Planning Commission Issues Report

Subject: Change of Zoning Issues Report

Meeting Date: April 23, 2012

Petition: P.Z. 02-2012 Mercy Health Systems (Chesterfield Village, SE Quadrant)

2. Parking Setbacks

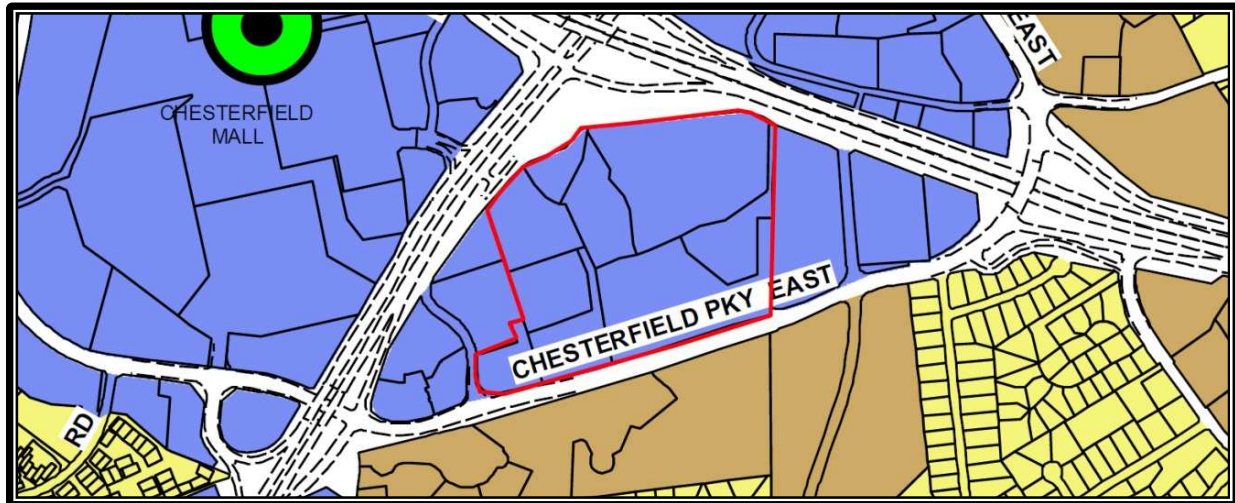
The revised Preliminary Plan shows a north-south internal roadway along the western side of the site setback approximately 10 feet from the property line. The 'UC' District regulations state that no parking area, internal drive, loading space, or parking structure shall be permitted within thirty (30) feet of the boundary of the 'UC' District. A modification of this standard would be required if the Commission would like to recommend approval of the proposed request as presented.

The property to the west of the proposed internal roadway is currently zoned “C-8” Planned Commercial District and is developed with several low-rise office buildings. As the properties would both be commercial uses, no landscape buffering would be required to separate the land uses under the City’s Tree Preservation and Landscape Requirements ordinance. Staff has not identified any issues or concerns with the proposed location of this roadway and supports the location in order to reduce the amount of land disturbance in other areas of the site.

- a. 30 feet from the northern, eastern, and southern boundary of the ‘UC’ District.
- b. ~~30~~ 10 feet from the western boundary of the ‘UC’ District.
